**Notification of a Decision taken by the Cabinet Member for
Regeneration, Environment and Housing**

Subject: Proposed waiting restrictions borough wide 2018 Batch 1 (statutory consultation)

Appendix A - Drawing Nos. Z27-660-01 – Z27-660-20

Appendix C – Revised Drawing Nos. Z27-660-03A, Z27-660-06A and Z27-660-14A

TITLE
Marina Avenue, KT3

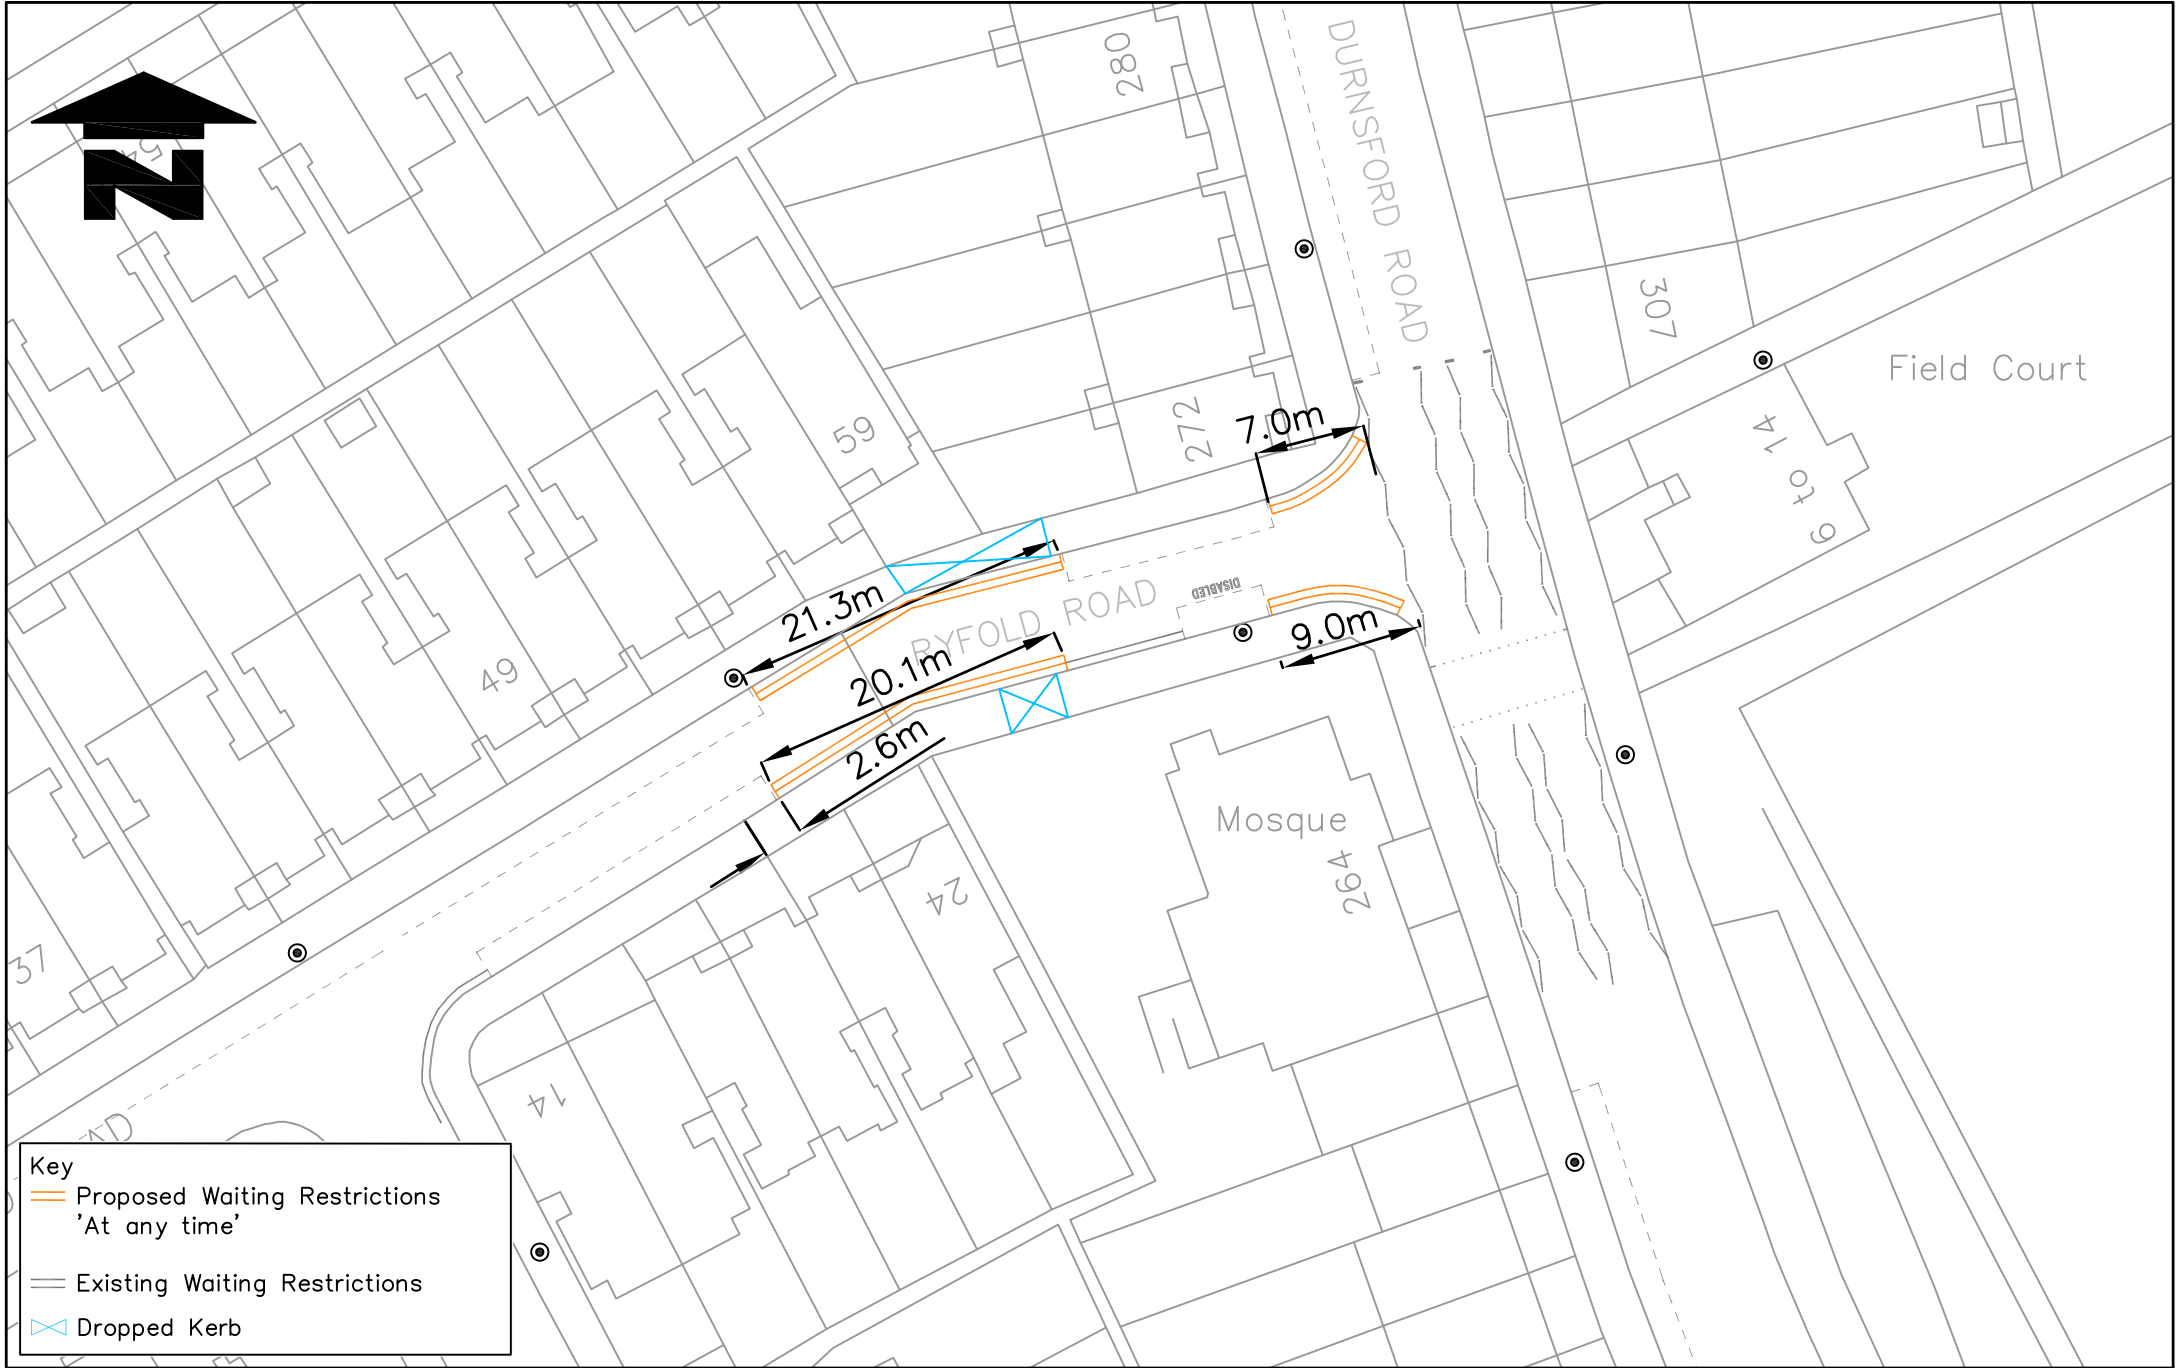
- 4.15 **Linkway, SM4.** There were 6 representations in support received for this proposal.
- 4.16 **Marina Avenue, KT3.** 8 representations were received with 7 in support and 1 objection.

- 4.17 The objection is based on loss of parking in an area already experiencing parking pressure and that waiting restrictions on the junction corners would increase the speed of moving traffic, however the objection is strongly in favour of waiting restrictions in the turning circle at the end of Marina Avenue.
